**NEW YORK STATE THRUWAY AUTHORITY
DEPARTMENT OF ENGINEERING**

**AMENDMENT NO. 1
TO**

**CONTRACT TAB 24-13
D214968
PAVEMENT REHABILITATION AND
MISCELLANEOUS WORK FROM MILEPOST
(MP) 467.0 TO MP 485.5 WESTBOUND AND
MP 483.0 TO MP 467.0 EASTBOUND
IN THE BUFFALO DIVISION
IN CHAUTAUQUA COUNTY**

**IN THE LETTING OF
APRIL 17, 2024**

TITLE OF PROJECT ROADSIDE IMPROVEMENTS	CONTRACT NUMBER: TAB 24-13
LOCATION OF PROJECT BUFFALO DIVISION MP 467.00 TO MP 485.50	DATE: 03/28/2024
TITLE OF DRAWING WORK ZONE TRAFFIC CONTROL EXIT 59 NIGHT TIME WESTBOUND EXIT RAMP CLOSURE	DRAWING NUMBER: WZP-6

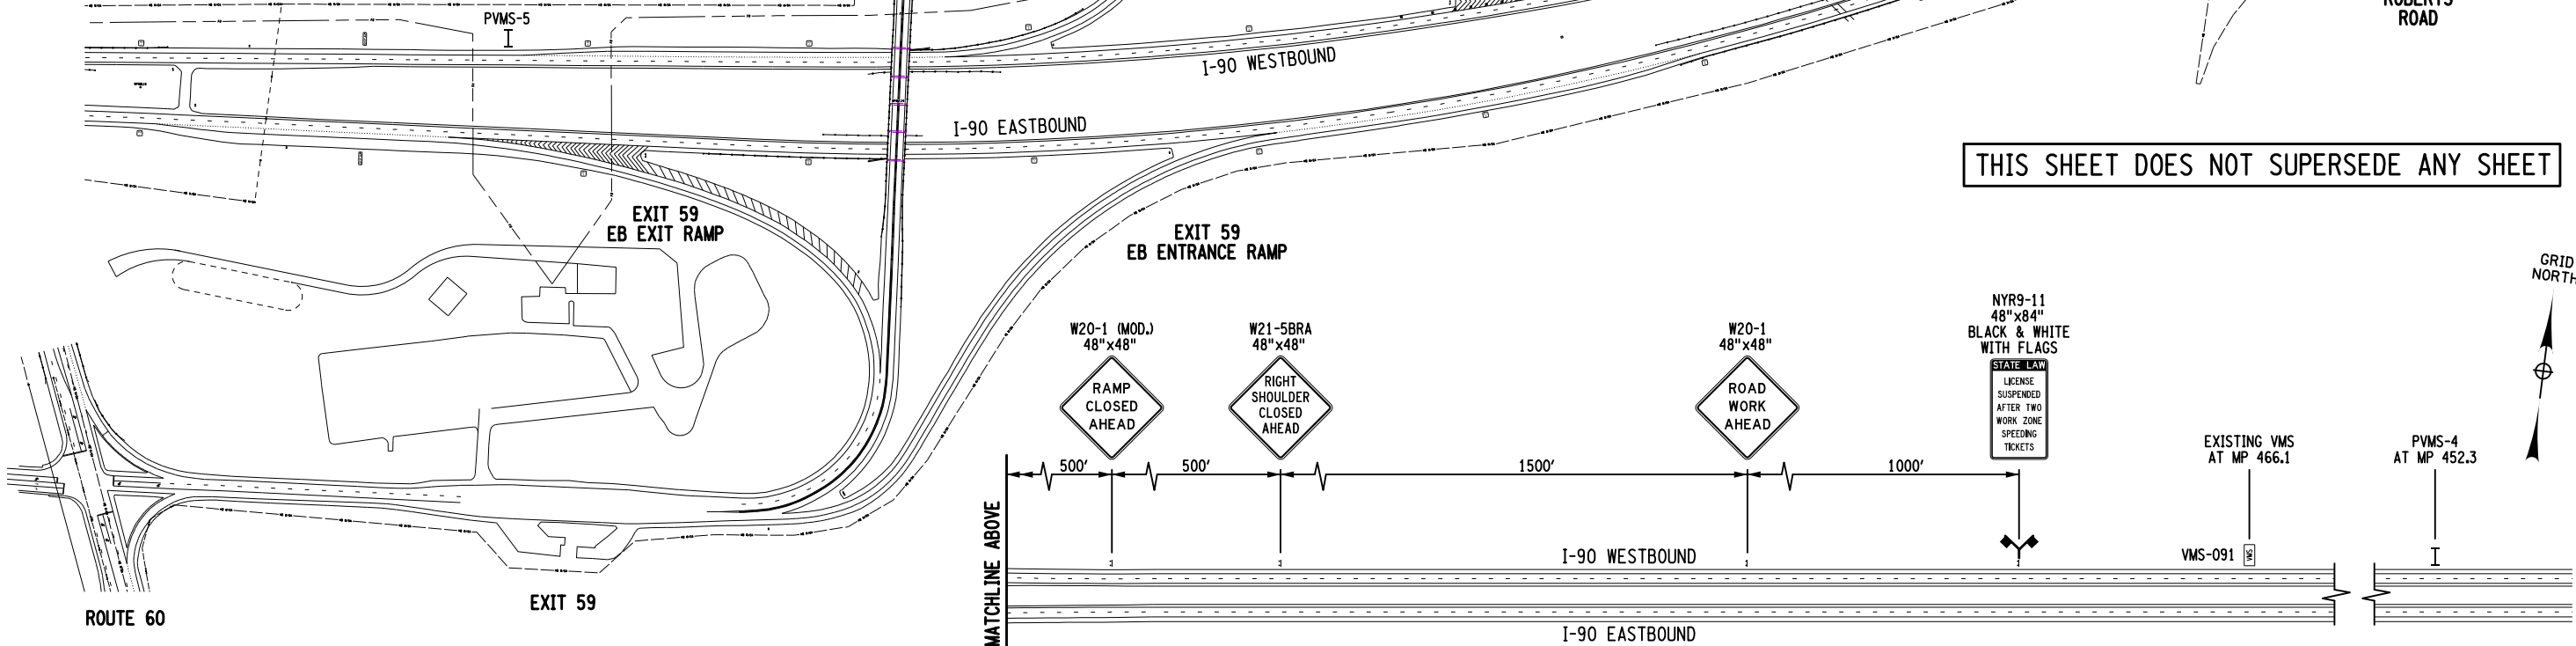
2. **ADD** new Drawing Number WZP-5, Sheet 26A-A1 of 126. Work Zone Traffic Control for Short Term Nighttime Construction at Exit 59 involving the Westbound Entrance Ramp Closure is now available.
3. **ADD** new Drawing Number WZP-6, Sheet 26B-A1 of 126. Work Zone Traffic Control for Short Term Nighttime Construction at Exit 59 involving the Westbound Exit Ramp Closure is now available.
